Comments Regarding Contribution C802.16maint-06/072

Doron Ezri, Eli Shasha and Itzik Kitroser

Runcom Technologies

Figure 1: The proposed gain sequence (Green) Vs. the exponential Kalman gain sequence (Blue)

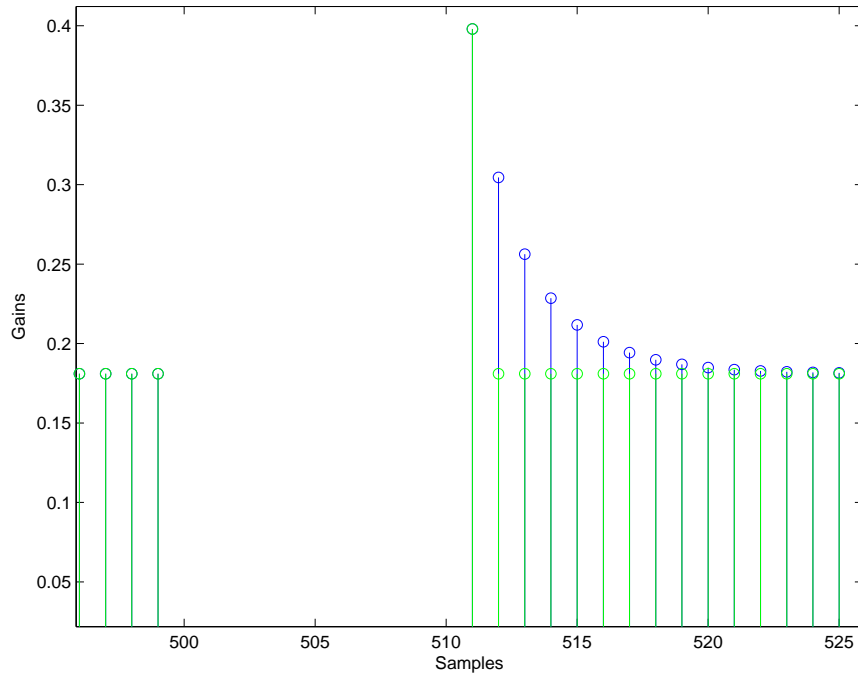
We note that in in the case of $n \neq 0$ Eq. (2) differs from (1) only in one instance (immediately after the non measured Frames). This behavior of the solution seems problematic since it significantly differs from standard

solutions for (mathematically) similar problems. The gain sequence of the filter (2) and that implied by standard Kalman theory is given in Fig. 1. The figure shows that the Kalman results in an exponentially decaying gain that is missing from (2). From an engineering point of view, the Kalman solution is much more intuitive because it is not reasonable that the gain differs only in the Frame after the non-measured Frames. Thus, Contribution C802.16maint-06/072 suggests replacing one (very) suboptimal solution (1) with another (2).

We propose to apply a (simple) adaptive solution to the problem of non-uniform sampling at hand. The proposed solution takes the form (for $k > 0$)

$$\hat{\mu}_{CINR}[k] = \hat{\mu}_{CINR}[k-1] + \frac{P^-[k]}{P^-[k]+1} (\text{CINR}[k] - \hat{\mu}_{CINR}[k]) \quad (3)$$

$$P^-[k+1] = \left(1 - \frac{P^-[k]}{P^-[k]+1}\right) P^-[k] + \frac{\alpha_{avg}^2}{1 - \alpha_{avg}} (n[k+1] + 1),$$

with initial conditions $\hat{\mu}_{CINR}[0] = \text{CINR}[0]$ and $P^-[1] = \frac{\alpha_{avg}^2}{1 - \alpha_{avg}} (n[1] + 1)$. Here again $n[k]$ is the number of non-measured Frames before the k -th measurement (it is important to note that $n[k]$ is a function of k). The derivation of (3) is given in the Appendix.

- Replace Eq. (146a) in C802.16maint-06/072 with Eq. (3).
- Replace "... and n is number of consecutive frames in which no measurement is made" (below Eq. (146a)) with "... and n[k] is number of consecutive frames in which no measurement is made before the k-th measurement".
